West Winder Bypass
CSSTP-0006-00(327), P.I. No. 0006327
Barrow County

Value Engineering Study Report

April 2010

ALT. NO.
24
Sht. 2 of 5

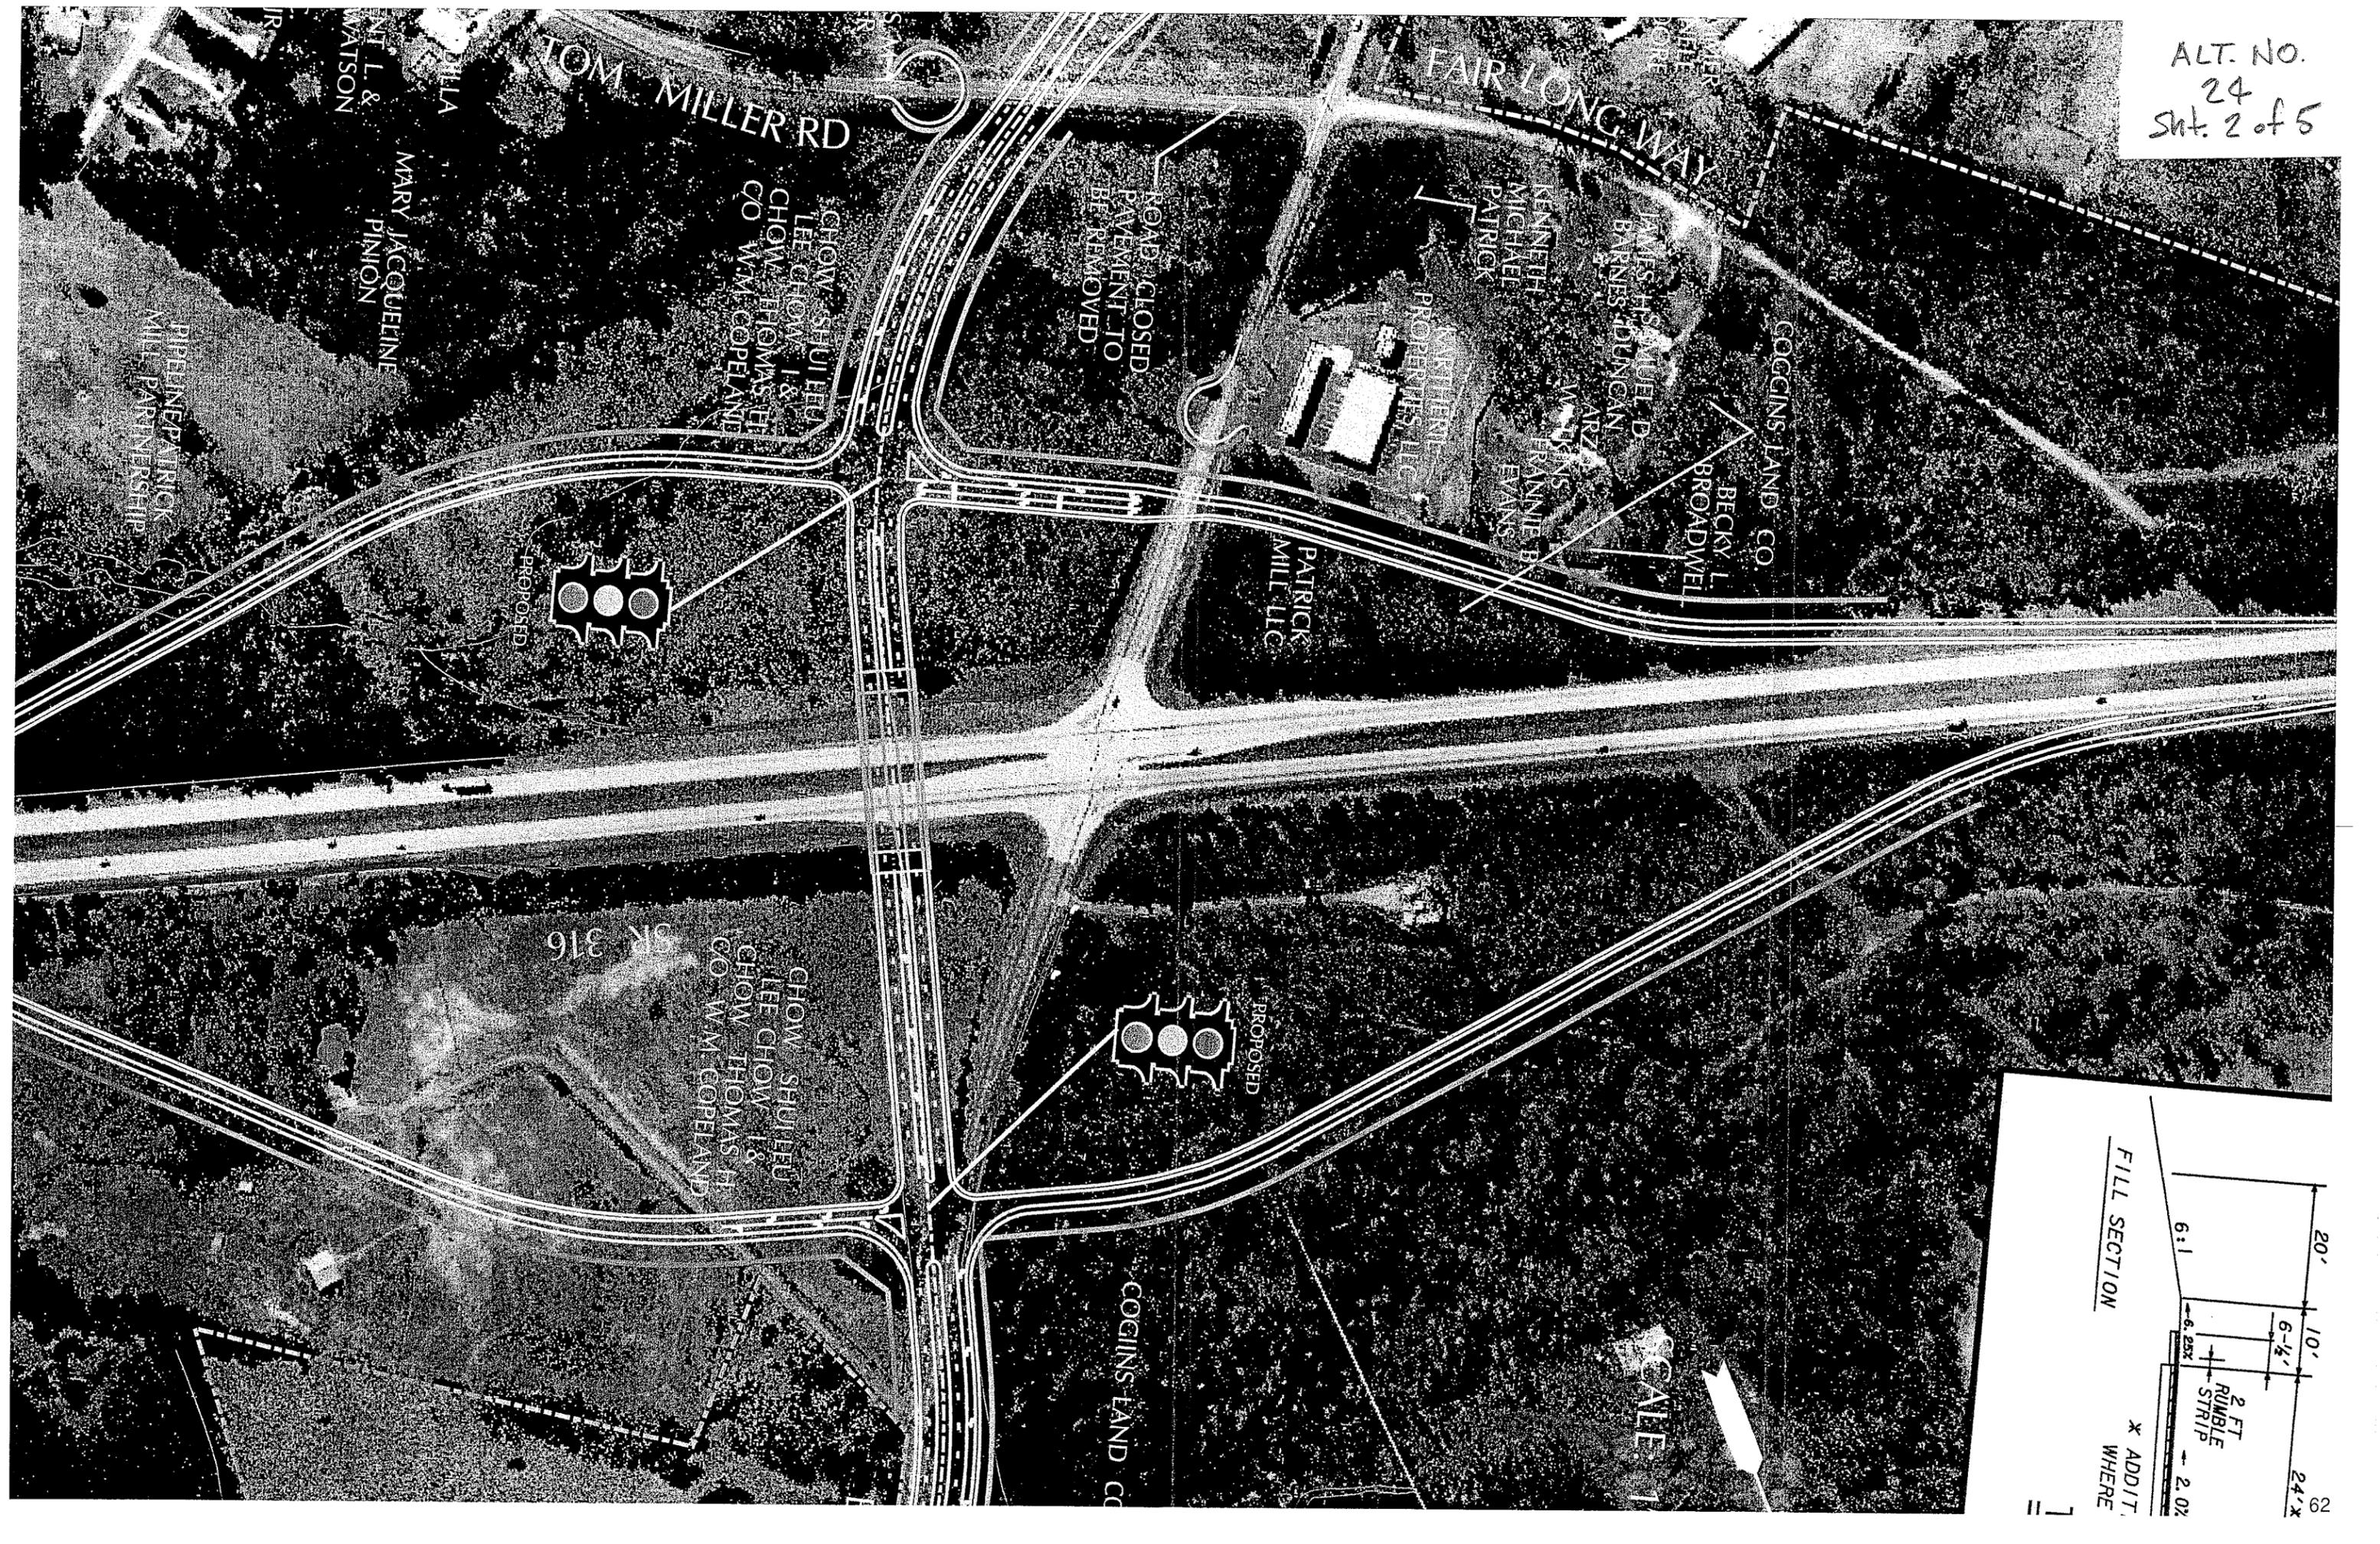
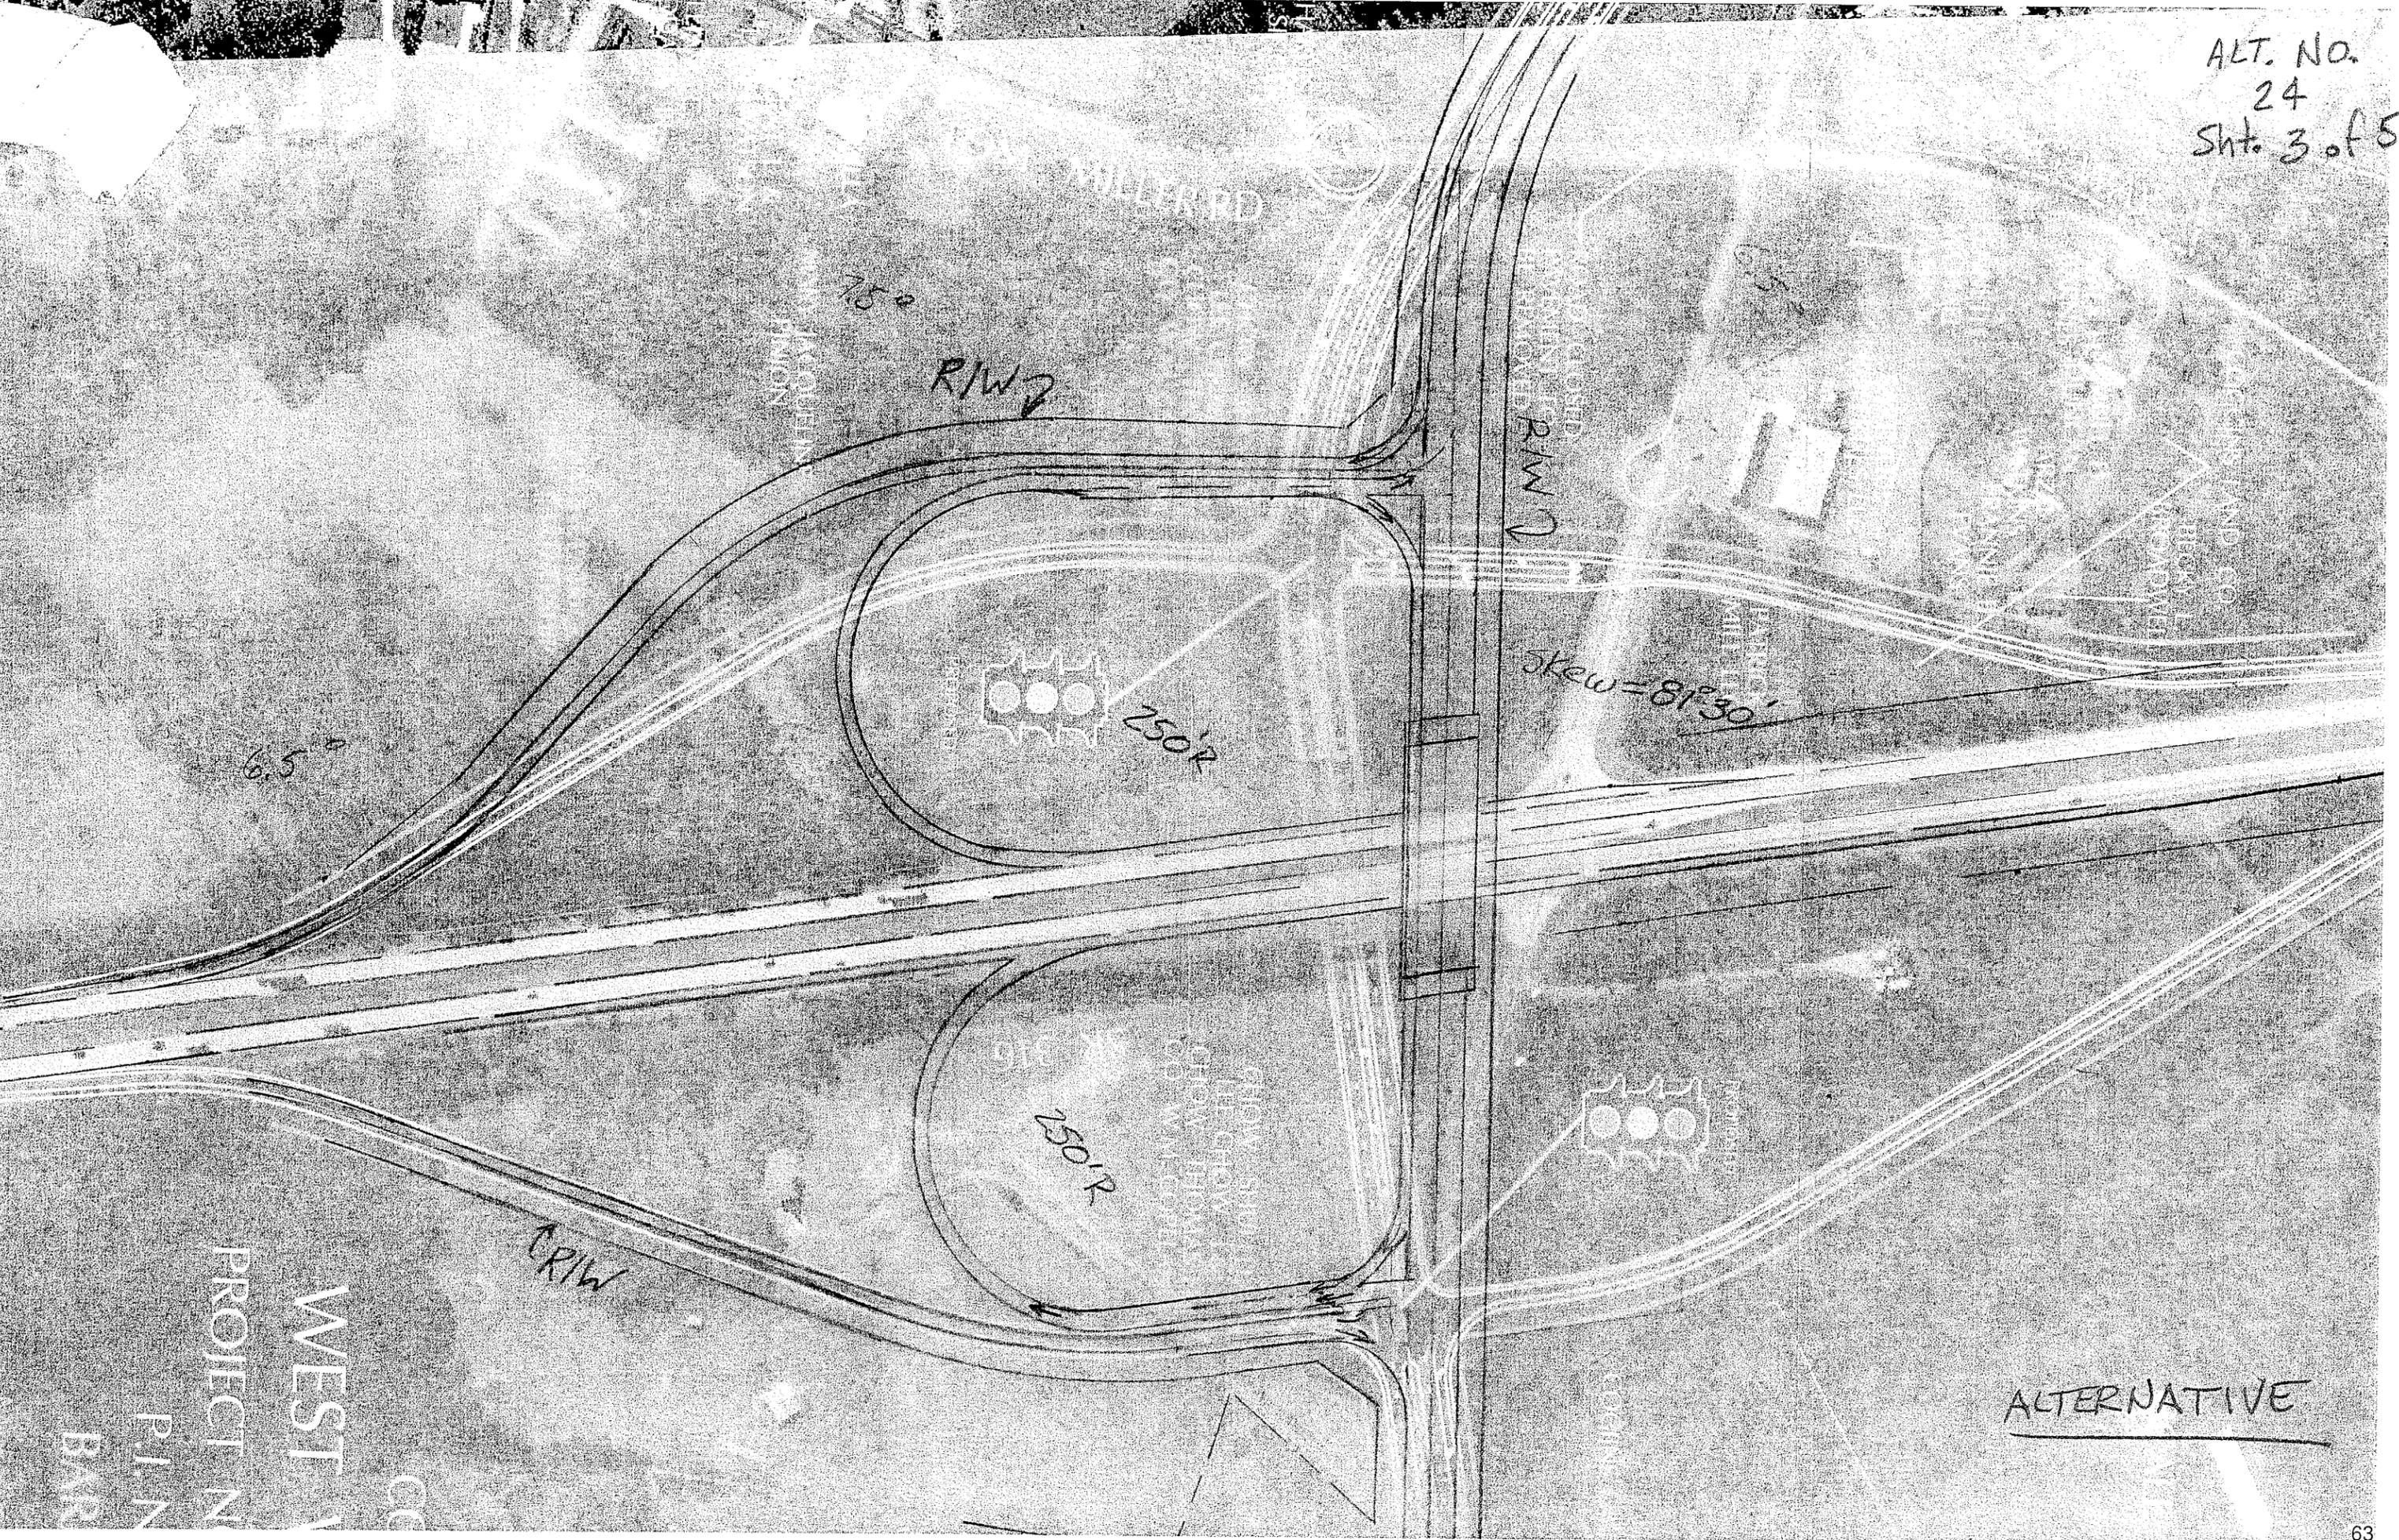
This design would eliminate the left turning movement for traffic returning from Atlanta and traveling to West Winder Bypass and replace it with a free right turn. However, vehicles desiring to travel towards Atlanta would have to make a left turn onto the loop ramp.

ALTERNATIVE NO.: 25

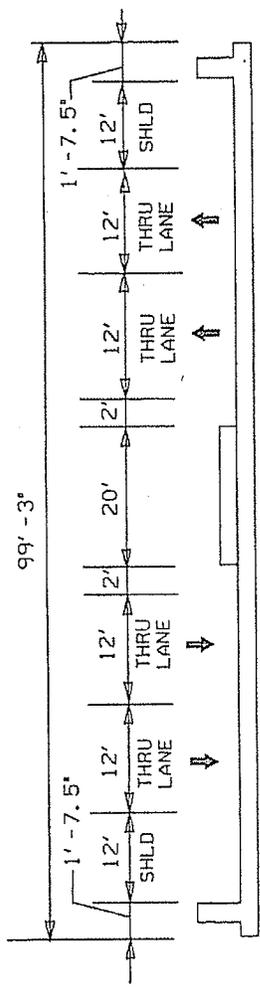
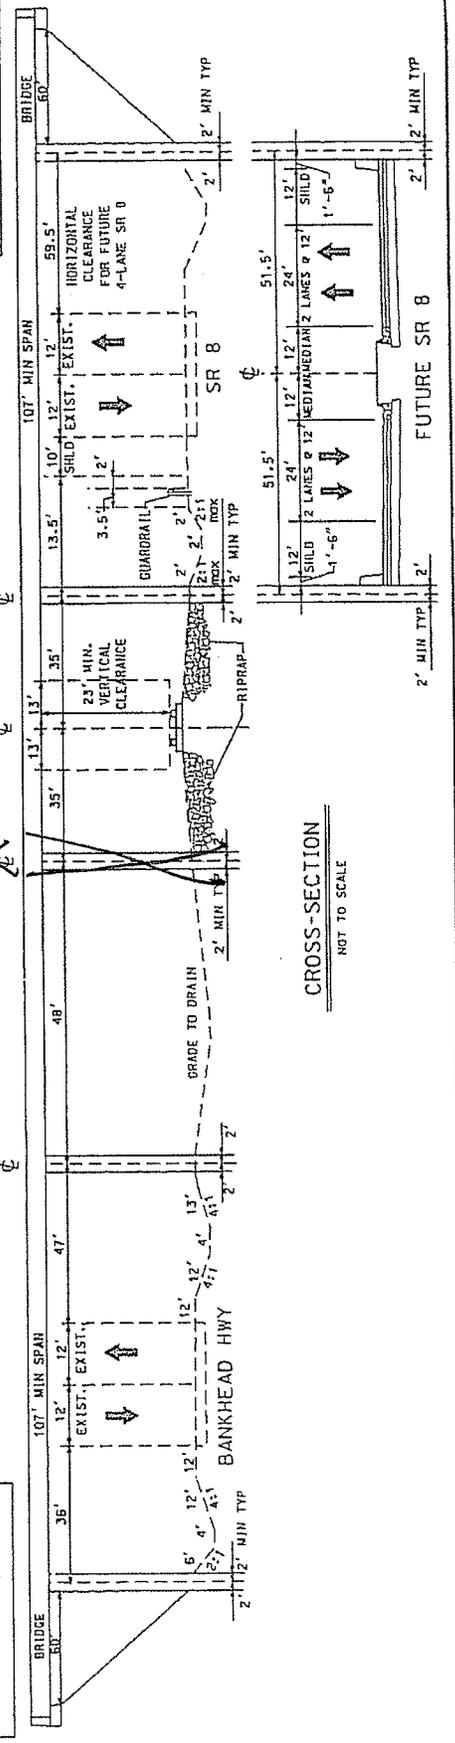
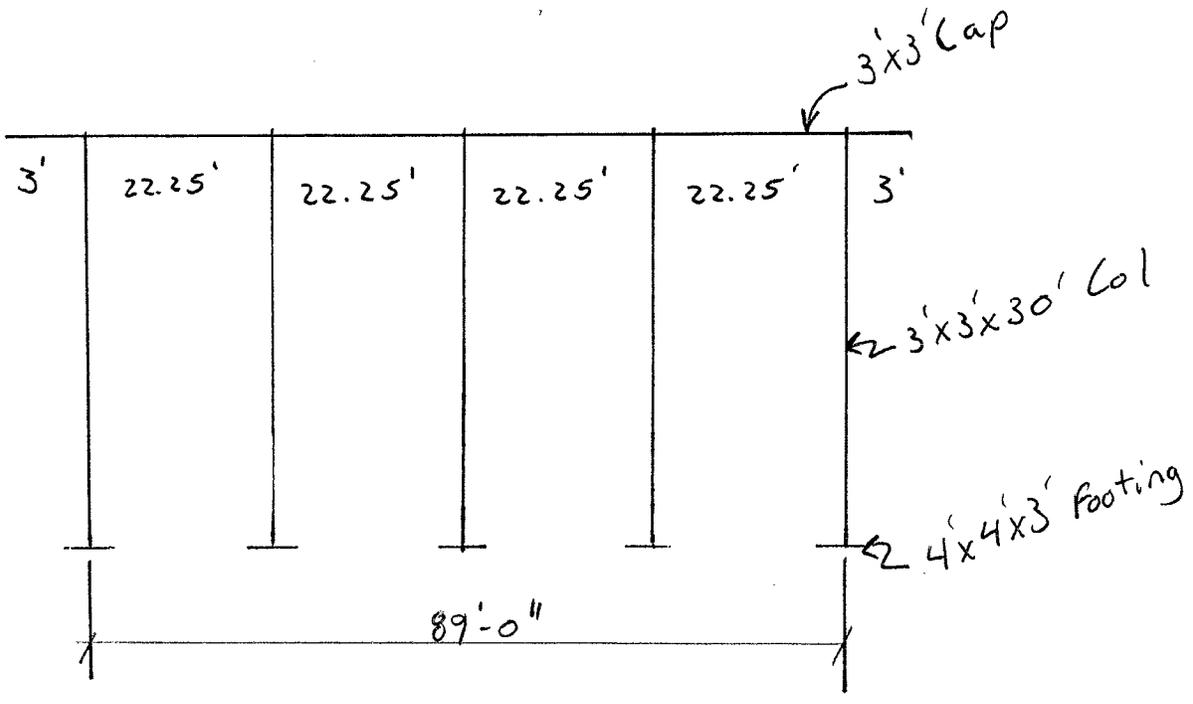
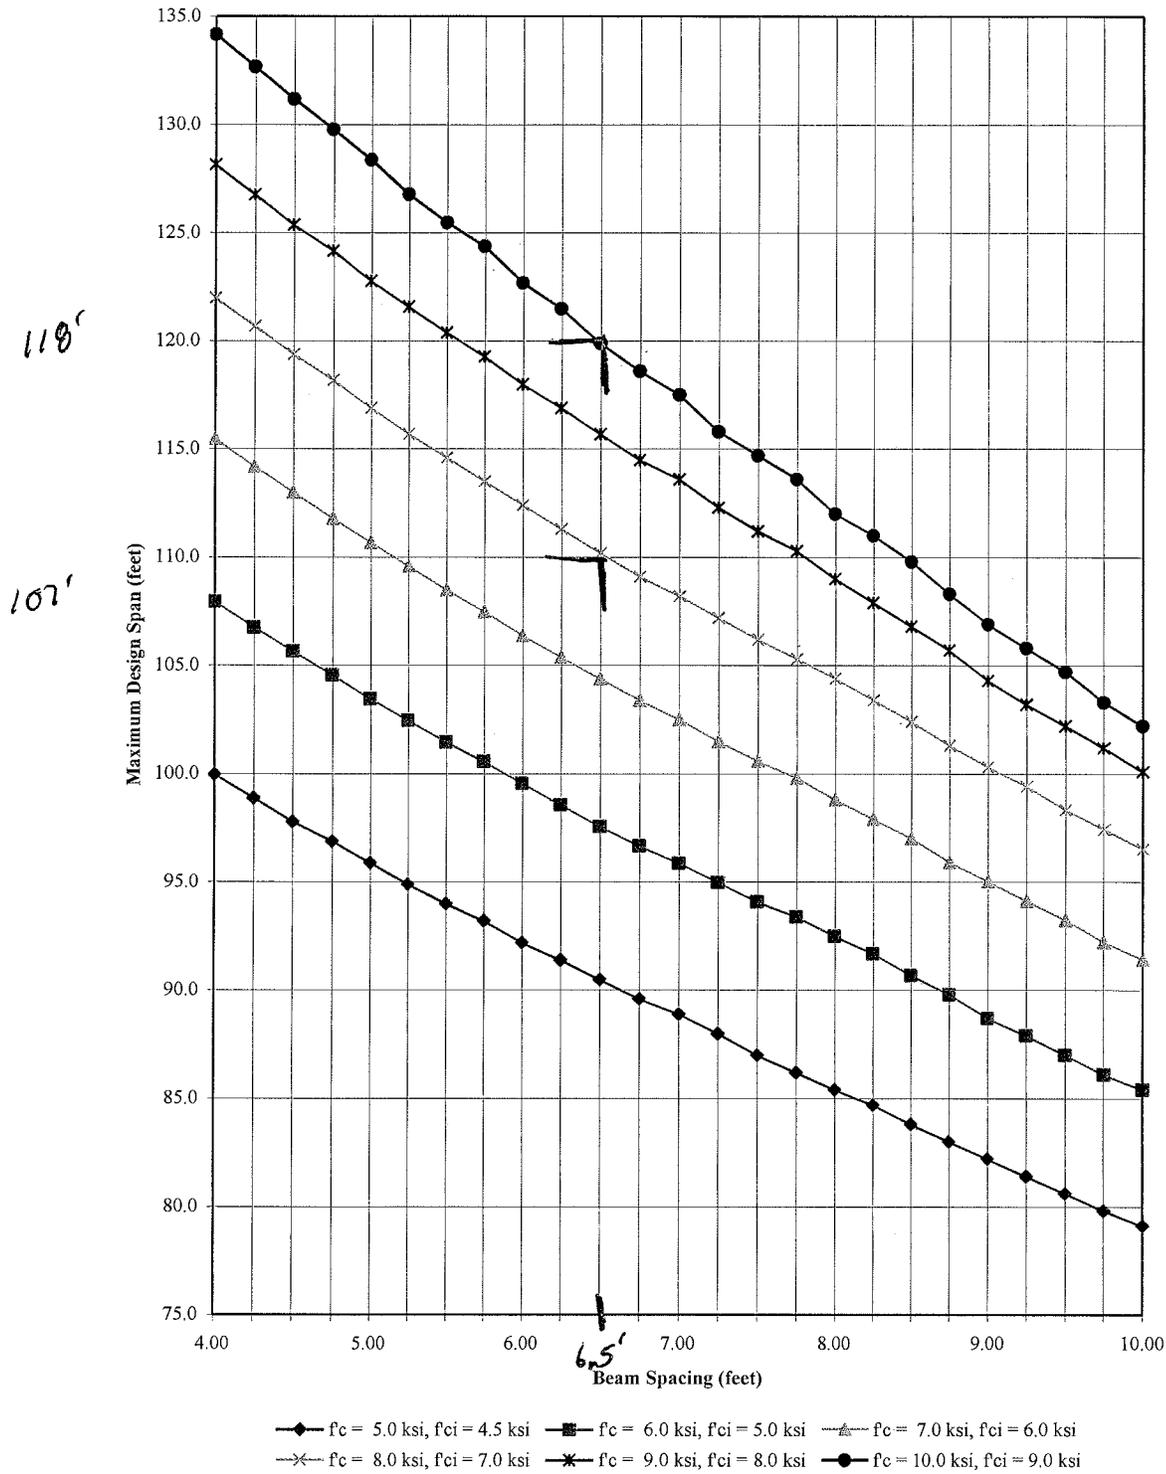
Remove the middle pier creating five spans of 60 ft., 107 ft., 118 ft., 107 ft. and 60 ft.

Removing the middle pier on the bridge near the railroad will create a 118-ft.-long middle span (48 ft. + 70 ft.), creating more horizontal clearance to the railroad. The removal of the pier will also decrease the construction time. The engineer will still be able to use the same beam type for the 107 ft. spans as the 118 ft. span, probably a Type IV beam.

- Calculate number of beams
 - Say 14 spaces at 6.5' = 91'
 - Overhang = $(99.25' - 91') / 2 = 4.125' = 4' - 1\frac{1}{2}"$
 - Cap width = $91' + 2' + 2' = 95'$
